Intel[®] 5 Series Chipset and Intel[®] 3400 Series Chipset

Specification Update

| February 2011

| Document Number: 322170-017

Figure 5-15. LVDS Signals and Swing Voltage

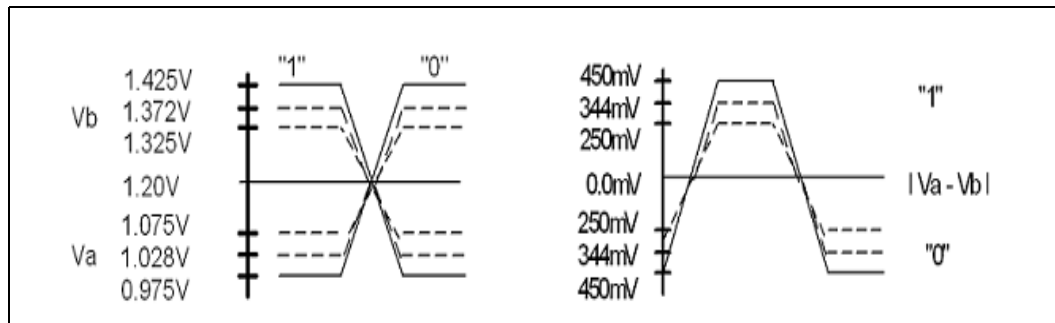
Figure 5-15 shows a pair of LVDS signals and swing voltage.

Figure 5-16. LVDS Clock and Data Relationship

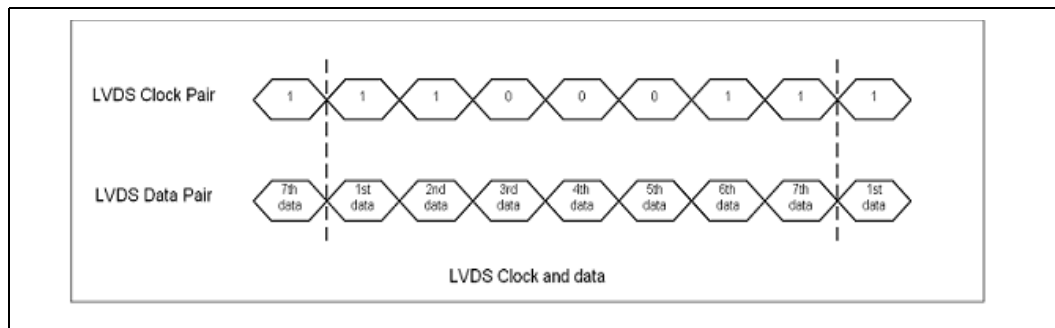
Logic values of 1s and 0s are represented by the differential voltage between the pair of signals. As shown in the Figure 5-16 a serial pattern of 1100011 represents one cycle of the clock.

Figure 5-17. Panel Power Sequencing

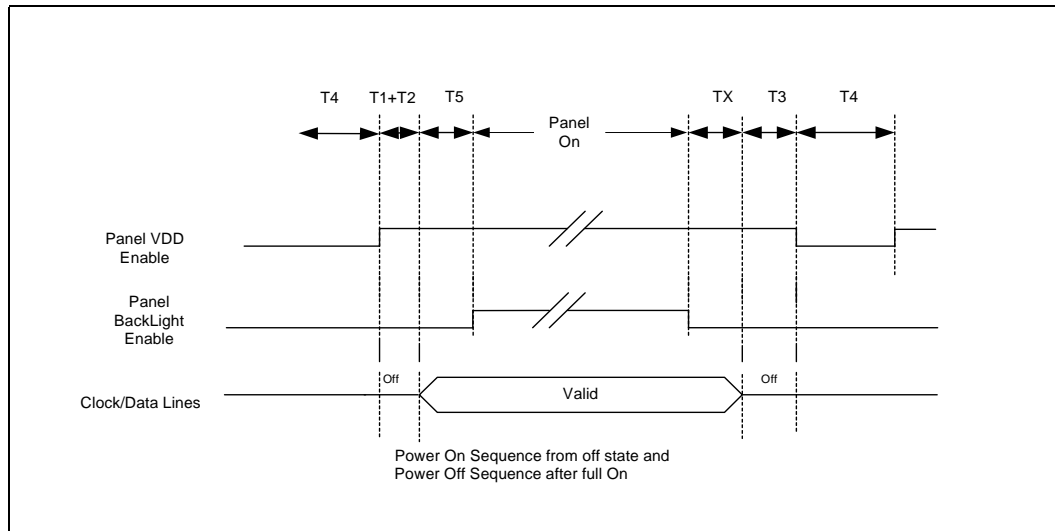
A defined power sequence is recommended when enabling the panel or disabling the panel. The set of timing parameters can vary from panel to panel vendor, provided that they stay within a predefined range of values. The panel VDD power, the backlight on/off state and the LVDS clock and data lines are all managed by an internal power sequencer.

NOTE: Support for programming parameters TX and T1 through T5 using software is provided.

Figure 5-18. HDMI Overview

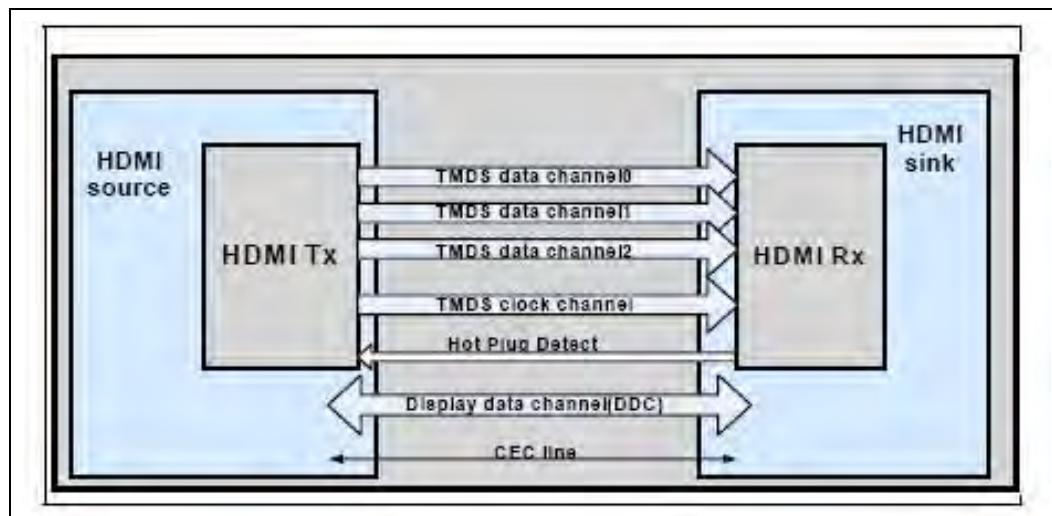
HDMI includes three separate communications channels: TMDS, DDC, and the optional CEC (consumer electronics control) (not supported by the PCH). As shown in Figure 5-18, the HDMI cable carries four differential pairs that make up the TMDS data and clock channels. These channels are used to carry video, audio, and auxiliary data. In addition, HDMI carries a VESA DDC. The DDC is used by an HDMI Source to determine the capabilities and characteristics of the Sink.

Figure 5-19. DisplayPort Overview

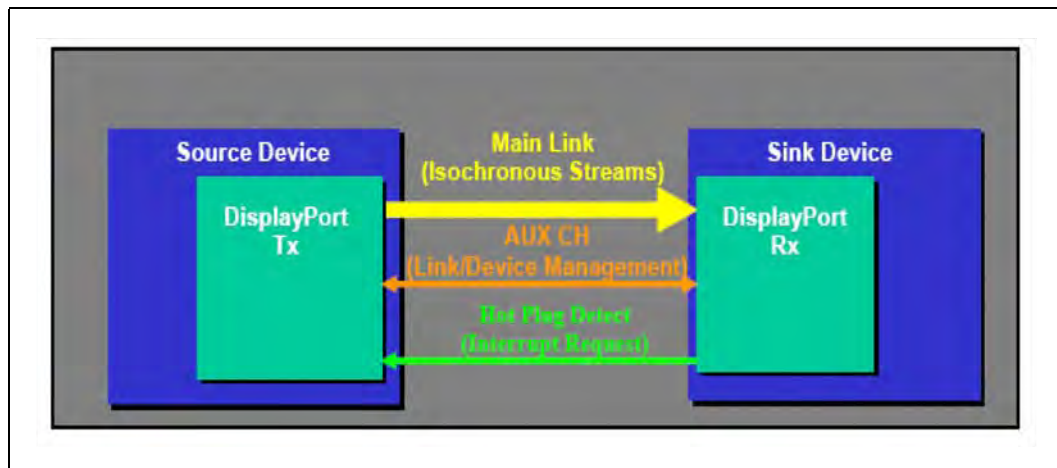
A DisplayPort consists of a Main Link, Auxiliary channel, and a Hot Plug Detect signal. The Main Link is a uni-directional, high-bandwidth, and low latency channel used for transport of isochronous data streams such as uncompressed video and audio. The Auxiliary Channel (AUX CH) is a half-duplex bidirectional channel used for link management and device control. The Hot Plug Detect (HPD) signal serves as an interrupt request for the sink device.

Figure 5-20. SDVO Conceptual Block Diagram

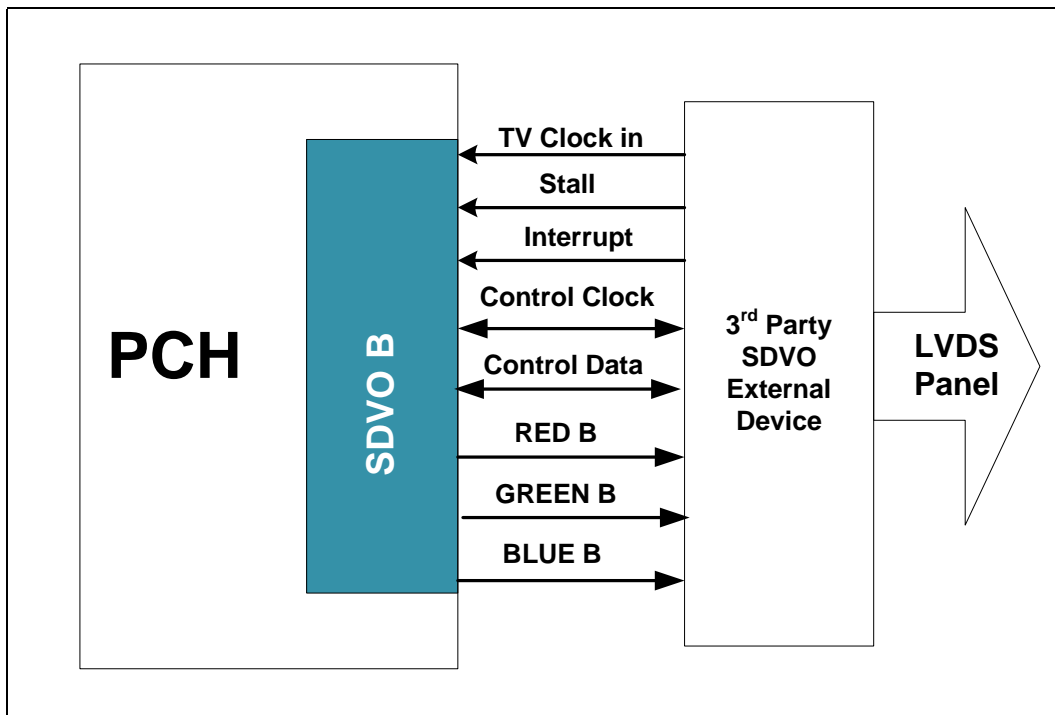
Serial Digital Video Out (SDVO) supports SDVO-LVDS only on the PCH. Though the SDVO electrical interface is based on the PCI Express interface, the protocol and timings are completely unique. The PCH utilizes an external SDVO device to translate from SDVO protocol and timings to the desired display format and timings.

SDVO is supported only on Digital Port B of the PCH.

Figure 8-30 Controller Link Receive Timings

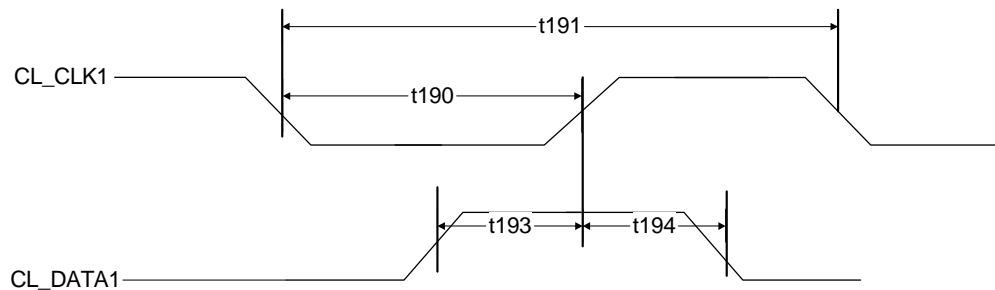
d. The following figures are added to section 8.9:
